## **Pilot Region-Based Optimization Program for Fund-Lead Sites in EPA Region 3**

### **Site Optimization Tracker: Havertown PCP Site Havertown, Pennsylvania**

EPA 542-R-06-006j  
December 2006  
[www.epa.gov](http://www.epa.gov)

December 30, 2005

**FIGURE 1-1. THE HAVERTOWN PCP SITE AND THE SURROUNDING AREA.**

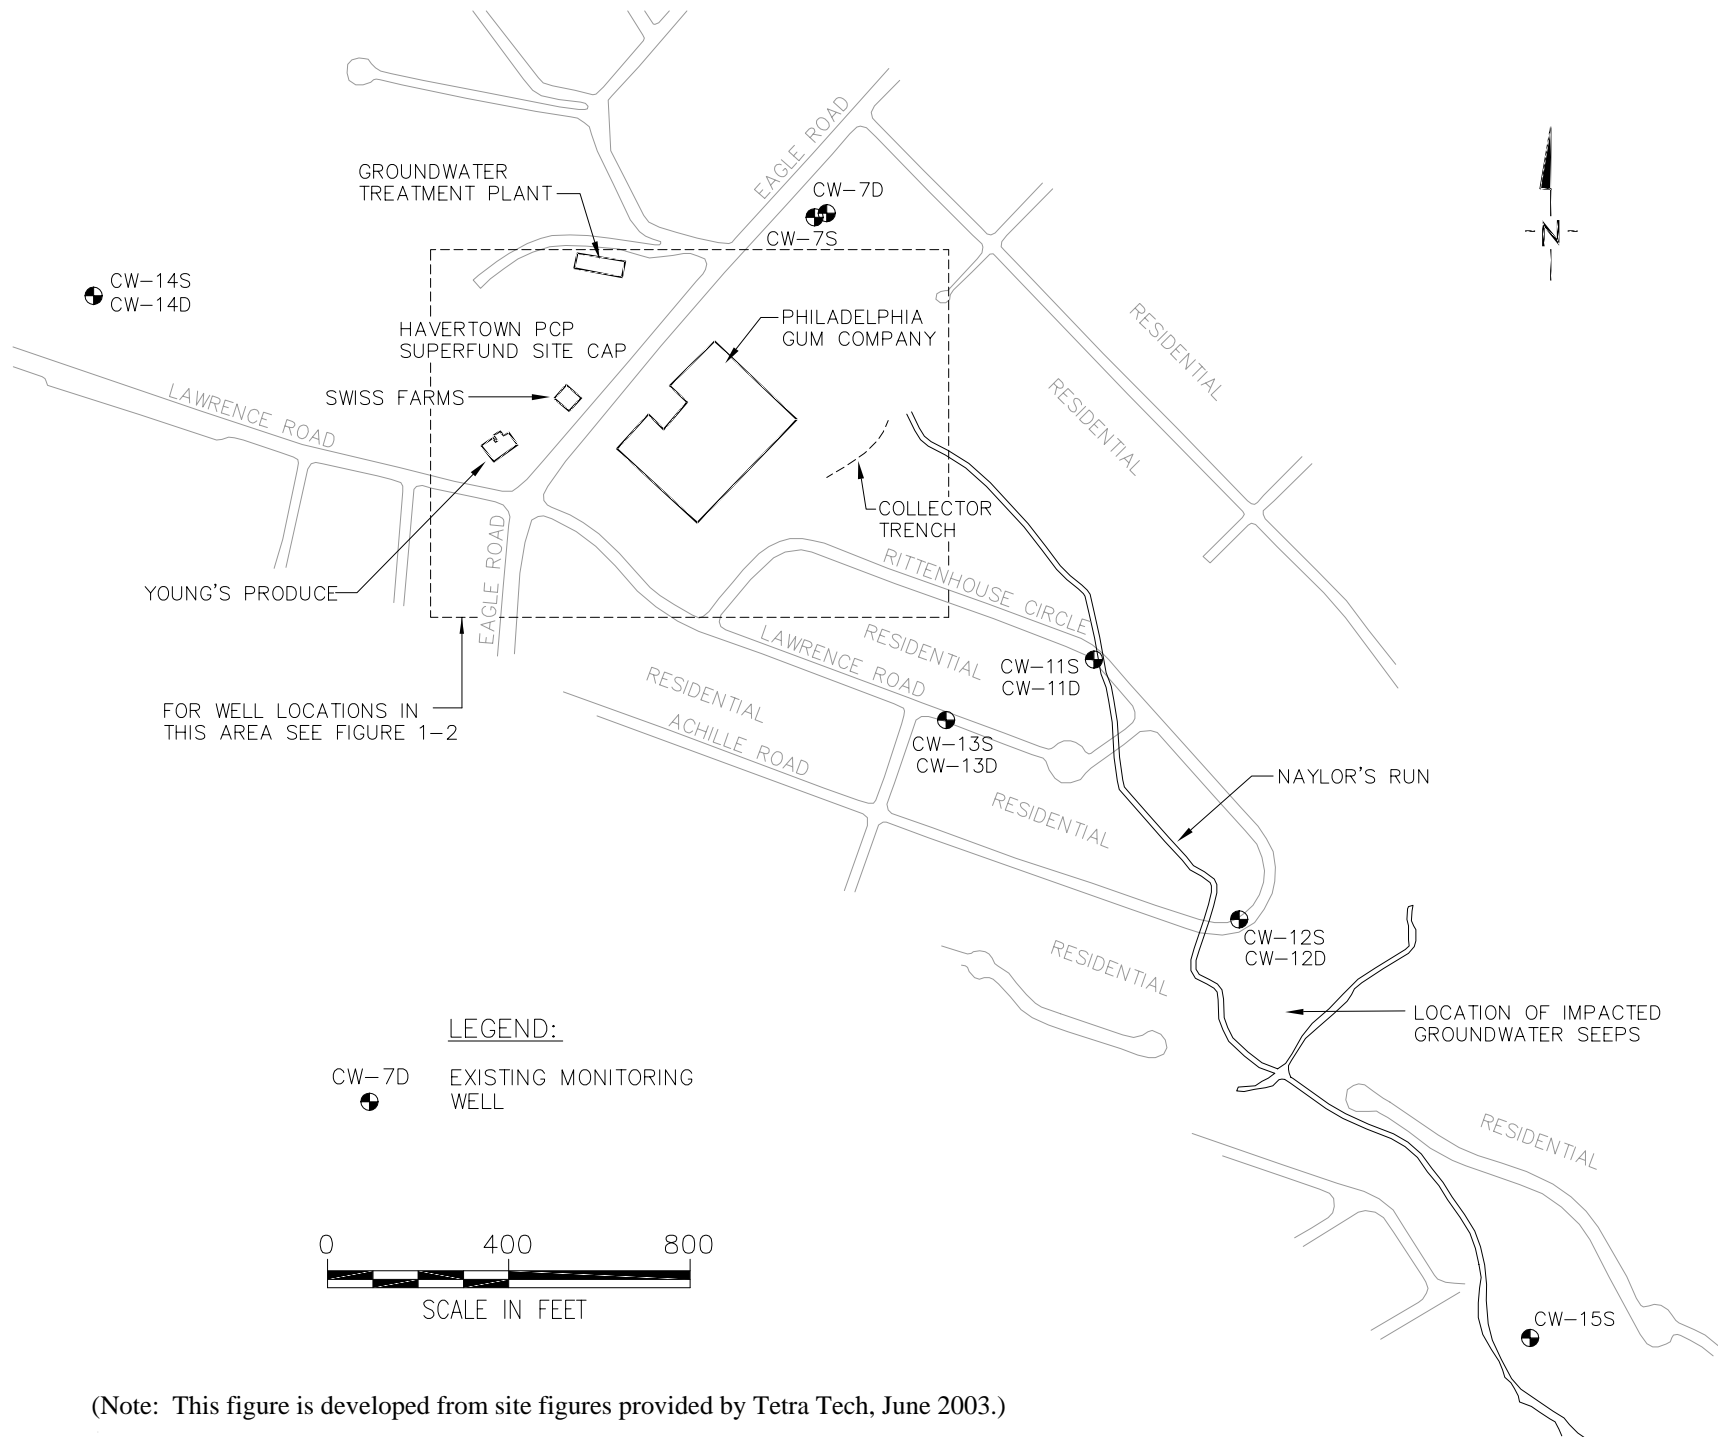
In 1999, the site team identified a contaminated seep adjacent to Naylor's Run (location indicated on Figure 1-1). By the Summer of 2003, the site team found an abandoned 12-inch sewer line that has likely been facilitating the transport of contaminated ground water downgradient and causing the seep. PCP concentrations of over 500 ug/L have been observed at this downgradient location even though upgradient monitoring points (such as the CW-12 cluster) show lower or undetectable concentrations. During the OSE visit, the site team showed the OSE team the seep area where impacted water was surfacing and indicated that addressing this sewer line, seep, and resulting contamination is a top priority.

A primary concern regarding capture is the presence of an abandoned 12-inch sewer line that is likely acting as a conduit for contaminated ground water. This sewer line apparently ends near Naylor's Run in the location of "impacted seeps" indicated on Figure 1-1.

Despite these success, the interim remedy is likely not suitable as the final remedy without modifications. First and foremost, the abandoned 12-inch sewer line that was first discovered in 2003 is likely facilitating transport of PCP and dioxin from ground water to a downgradient location. PCP concentrations in seeps as high as 750 ug/L have been detected. Human and other receptors can be exposed to this contamination if it is not controlled or removed.

Conditions in Naylor's Run have improved substantially due to the operation of the OU2 interim remedy; however, portions of Naylor's Run still have substantial impacts likely due to a 12-inch sewer line providing a conduit for contaminated ground water to reach the surface and discharge into Naylor's Run. Seep concentrations of PCP have been as high as 750 ug/L and sediment PCP concentrations have been as high as 6,200 ug/kg. Dioxin concentrations are also elevated. This area is indicated on Figure 1-1.

**FIGURE 1-3. EXTENT OF PCP CONTAMINATION IN THE SHALLOW ZONE (APPROXIMATELY 5 TO 20 FEET BGS).**

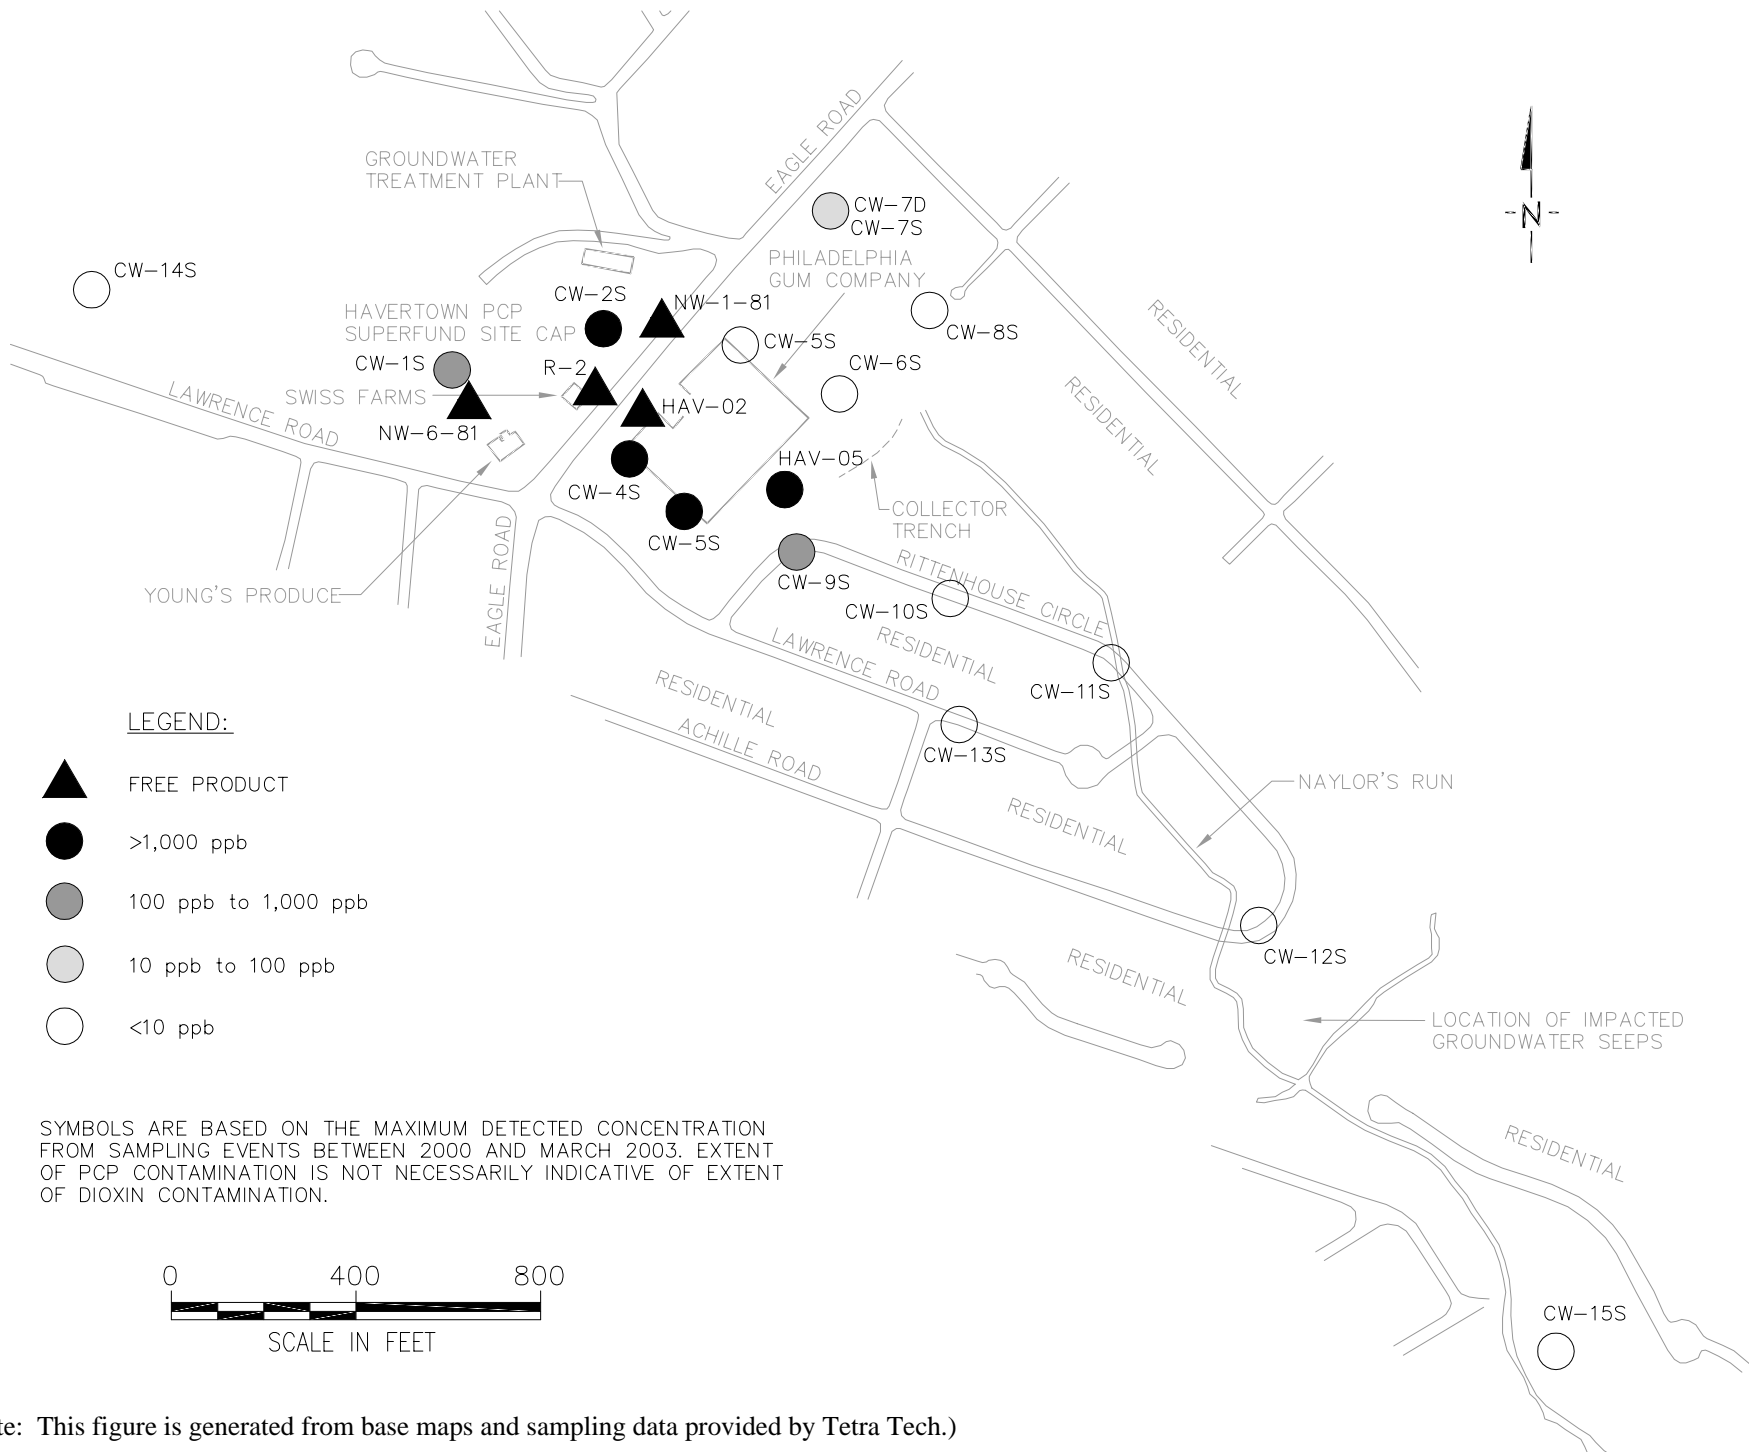
Figure 1-3 shows the extent of PCP contamination near the NWP and PCG properties in the shallow aquifer (overburden), and Figure 1-4 shows the extent of PCP contamination in the same area for a deeper aquifer interval (fractured bedrock). The highest detected levels of PCP at the time of the OSE are 13,000 ug/L in R-2, 30,000 ug/L in HAV-02, and 8,700 ug/L in HAV-04 (March 2003 sampling

The ground water sampling is also relatively incomplete in terms of delineating the plume, particularly to the south and in the vertical direction. The wells in the CW-4 and CW-5 clusters are the southern most wells near Eagle Road, and as shown in Figures 1-3 and 1-4, the PCP concentrations at these wells exceed 1,000 ug/L. With no additional wells to the south, the PCP plume is not delineated. This lack of delineation affects the preliminary capture zone analysis conducted above because the degree of capture cannot be determined without full delineation. As depicted in Figure 1-4, a number of deep wells with screened intervals down to approximately 50 feet below ground surface have concentrations exceeding 1,000 ug/L. Without deeper wells, the PCP plume cannot be considered delineated vertically. In EW-1 through EW-3 (extraction wells located upgradient of the collector drain that have never been used for pumping), the concentrations are also above 1,000 ug/L. These wells are screened from approximately 40 to 80 feet bgs, whereas the collector drain is completed to approximately 16 feet bgs. With this relatively long screened interval, the vertical extent of contamination cannot be determined. The contamination may only be present near the tops of these relatively long screened intervals, but it may also be present at deeper levels. In addition, these wells may be acting as conduits, allowing contamination at approximately 40 feet to migrate to depths near 80 feet. The upward gradient in this area due to the operation of the collector drain makes this downward migration unlikely, but this possibility should not be eliminated without deeper sampling.

To delineate the plume vertically, deeper wells should be installed in multiple locations (perhaps up to four locations). In addition to delineating the plume, these wells would provide monitoring points to confirm that the final remedy (when implemented) prevents contamination from migrating at depth. Due to the high concentrations found as deep as 50 feet below ground surface, it is likely that contamination is also present from 50 to 60 feet and possibly from 60 to 70 feet. Therefore, for delineation, the appropriate depths of the wells might be from 70 to 80 feet below ground surface, but a more appropriate depth may be determined by the site team after further reviewing historical data and well logs. The well logs from the construction of the extraction wells may be helpful. Alternatively, drilling techniques where different depths are sampled as drilling occurs (to determine a final screen interval), using packers, can be utilized.

*Co-located with CW-9* – CW-9D is approximately 50 feet deep and has PCP concentrations above MCLs. In addition, CW-9D is downgradient of CW-4D and CW-5D, which have PCP concentrations as high as 5,200 and 1,700 ug/L, respectively. Co-locating a deep well (approximately 70 to 80 feet deep) with CW-9D should vertically delineate contamination in this area. Furthermore, the enhanced CW-9 cluster (i.e., with wells at three depths) should provide a downgradient monitoring point to confirm that the final remedy (when implemented) provides capture of the contamination found at CW-4D and CW-5D. If capture is adequate, concentrations at the three CW-9 wells should decrease to background (i.e., non-detect) over time.

*Co-located with CW-13* – CW-13D is the deepest downgradient point with contamination above the MCL. It had a concentration of 44 ug/L in October 2002. This deep well should provide vertical delineation of this contamination. Furthermore, along with the new deep wells at CW-9 and downgradient of the collector drain, this enhanced CW-13 cluster (i.e., with wells at three depths) should provide downgradient monitoring points (assuming deep ground water flow is in the same direction as ground water flow at shallower intervals) to enhance the capture zone evaluation of the final remedy (when implemented).
